**TOWNSHIP OF SOUTH WHITEHALL
LEHIGH COUNTY, PENNSYLVANIA**

**C. PROPOSED COMMERCIAL DEVELOPMENT 1810 PA ROUTE 309
MAJOR PLAN 2020-103**

TO: PLANNING COMMISSION
FROM: GREGG ADAMS, PLANNER
**SUBJECT: PROPOSED COMMERCIAL DEVELOPMENT 1810 PA ROUTE 309
MAJOR PLAN 2020-103
REQUEST FOR PRELIMINARY/FINAL PLAN REVIEW**
DATE: DECEMBER 13, 2021
**COPIES: BOARD OF COMMISSIONERS, R. COPE, D. MANHARDT, L. HARRIER,
D. TETTEMER, L. PEREIRA, ESQ., APPLICANT, SUB. FILE 2020-103**

RE: 1810 PA Rte 309 Convenience Store Land Development Plan
SWT Major Plan # 2020-103

SHEET NUMBER:
C-201

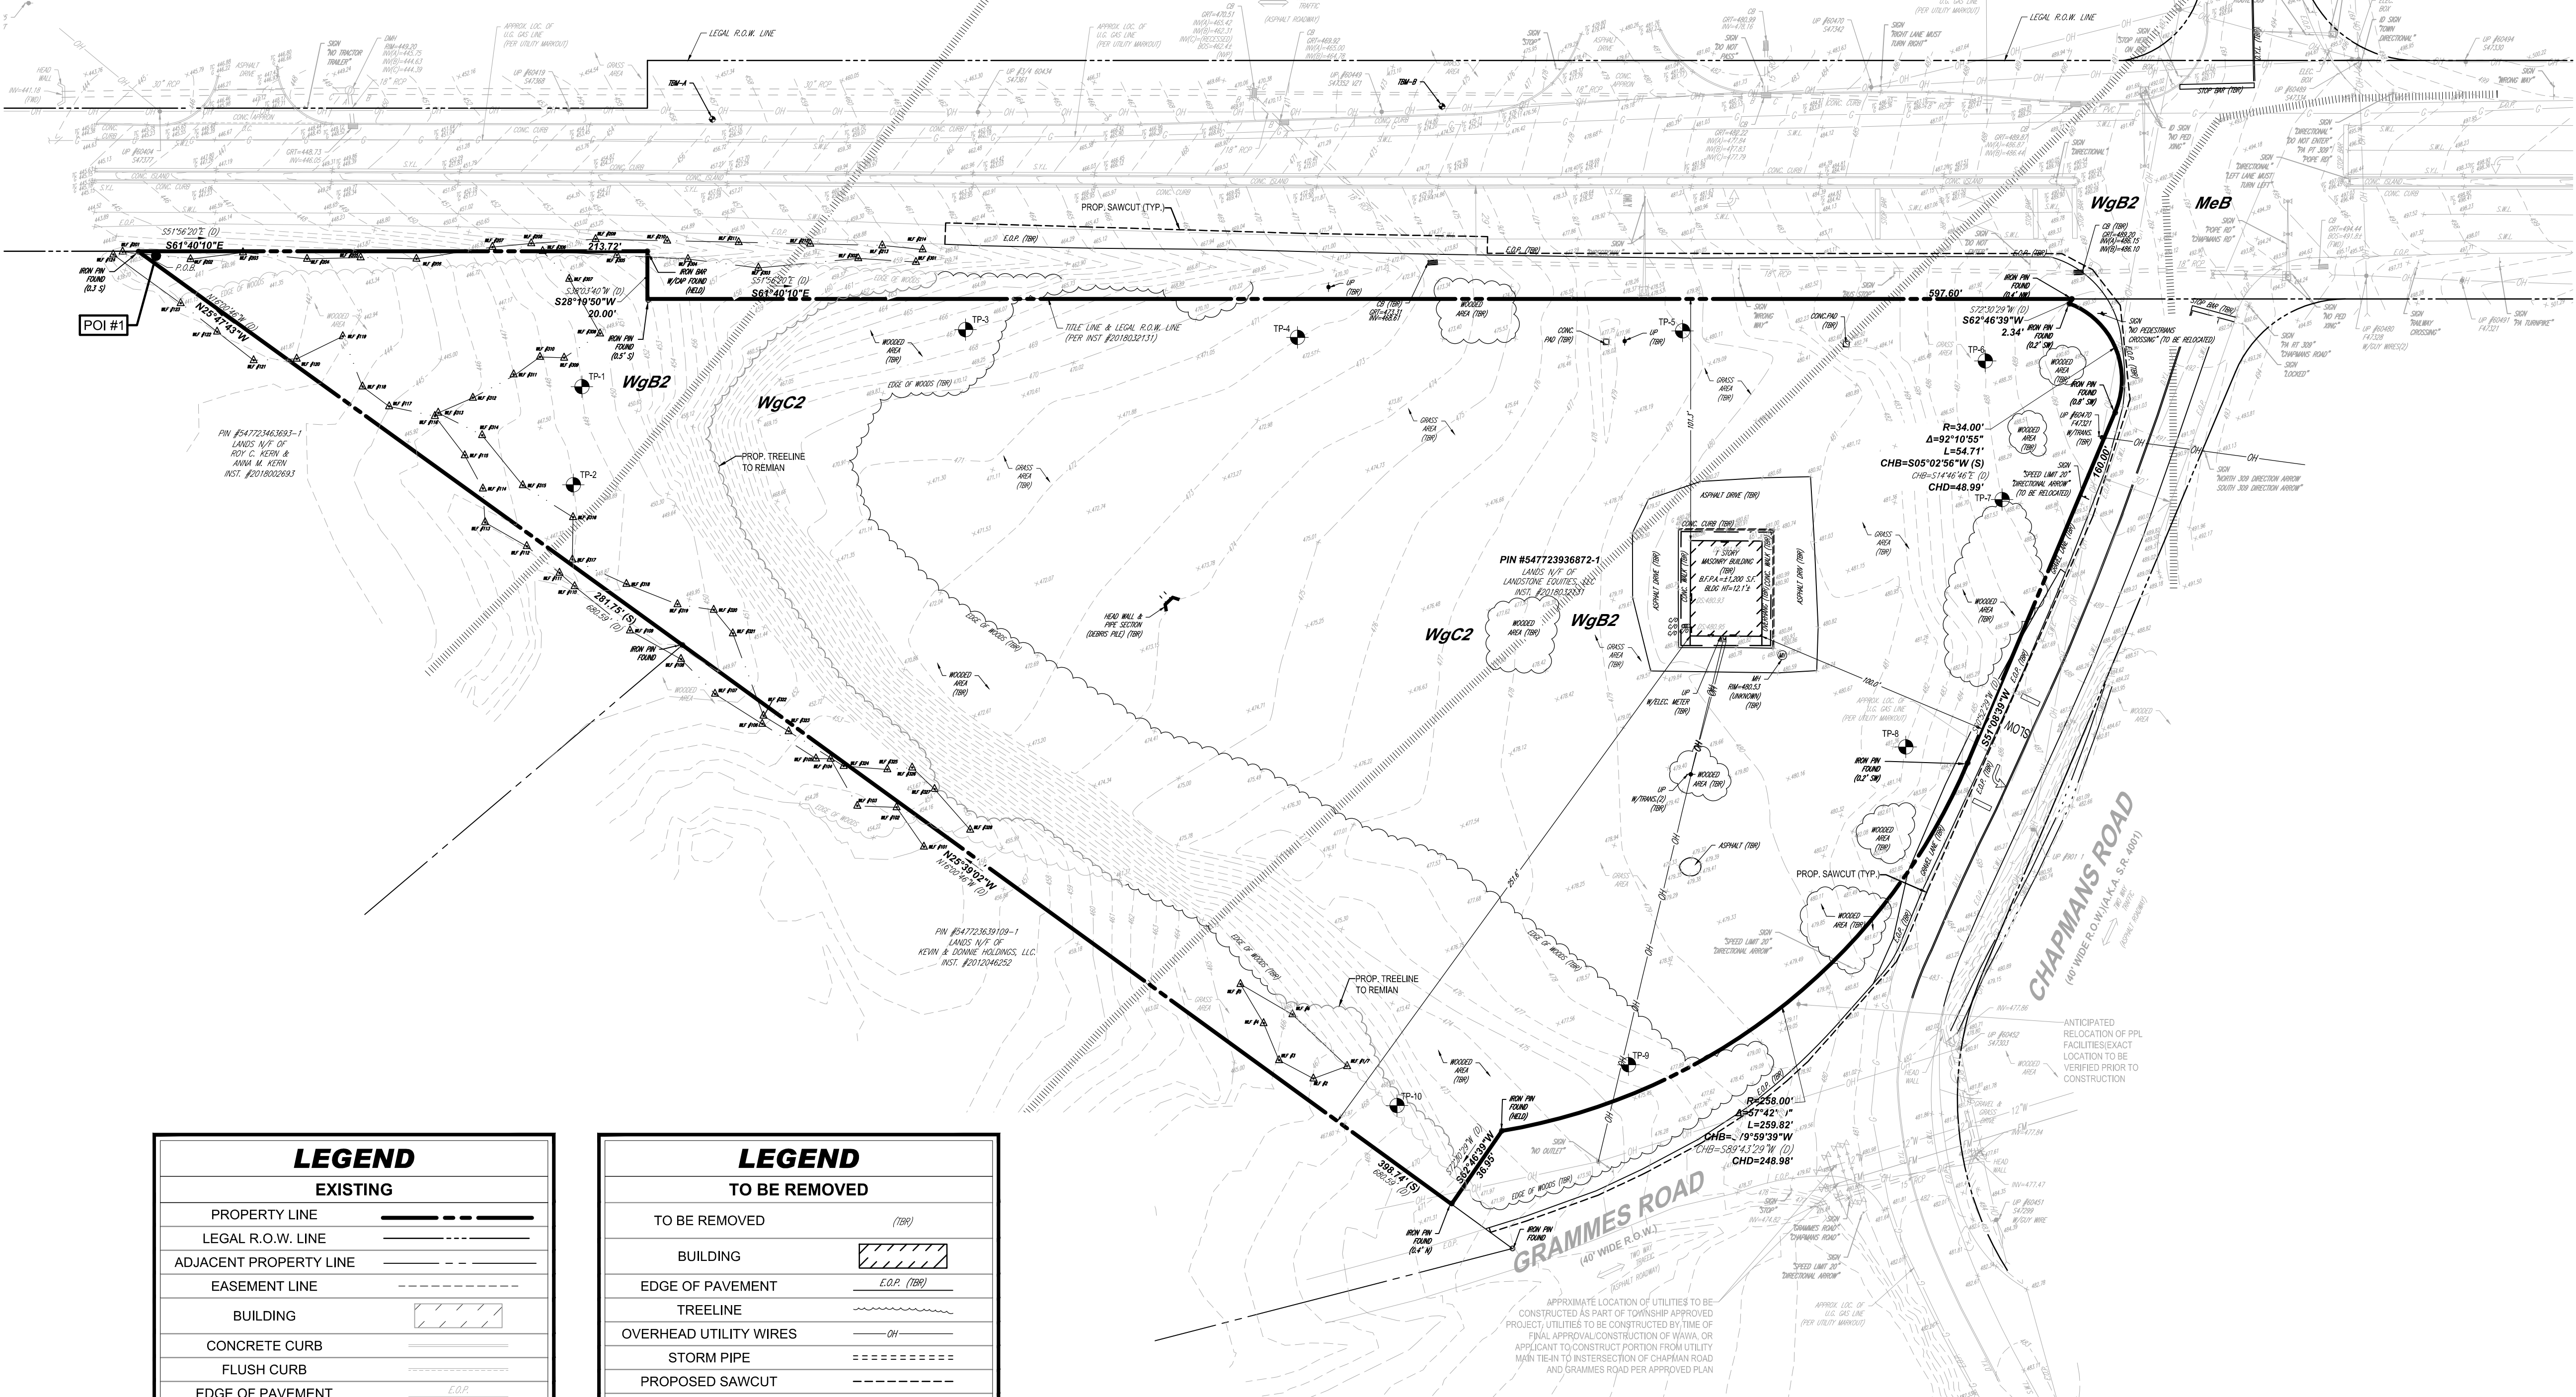
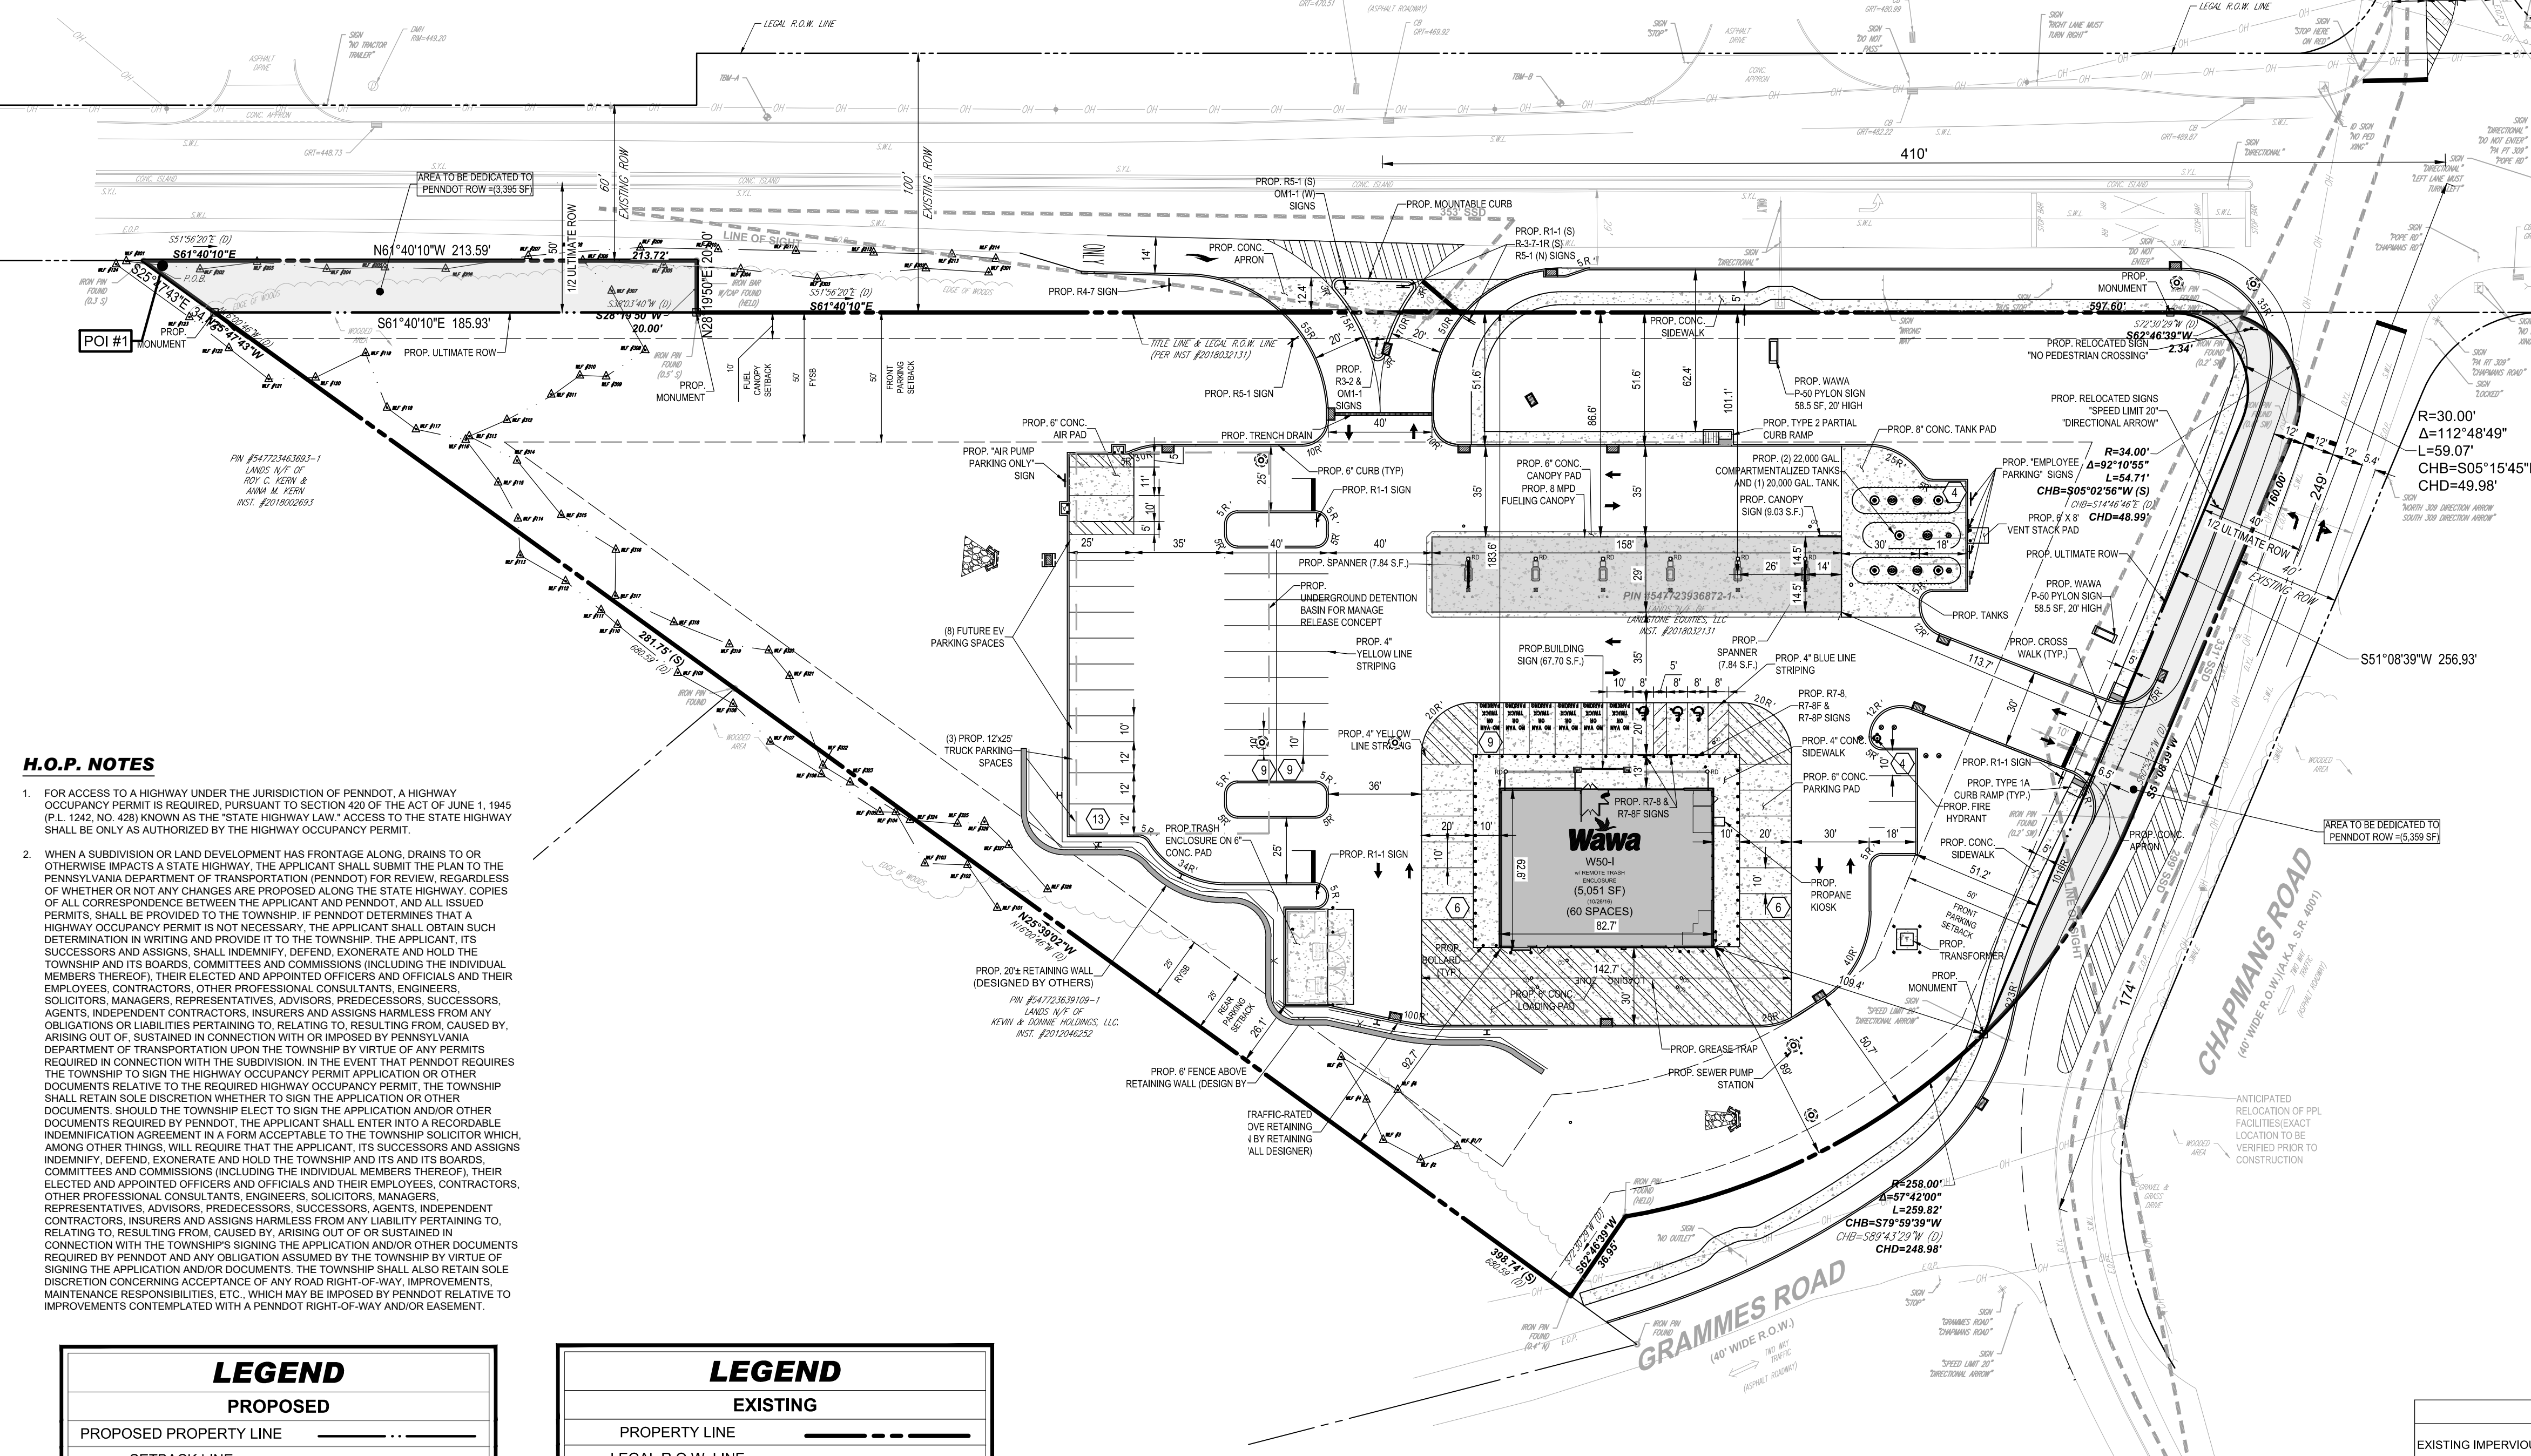
1. **SALDO 312-12(21)** - Field location of the existing improvement at the adjoining property along Grammes Road shall be shown on the plan. Also, the location of the existing utility poles along Grammes Road shall be field verified.
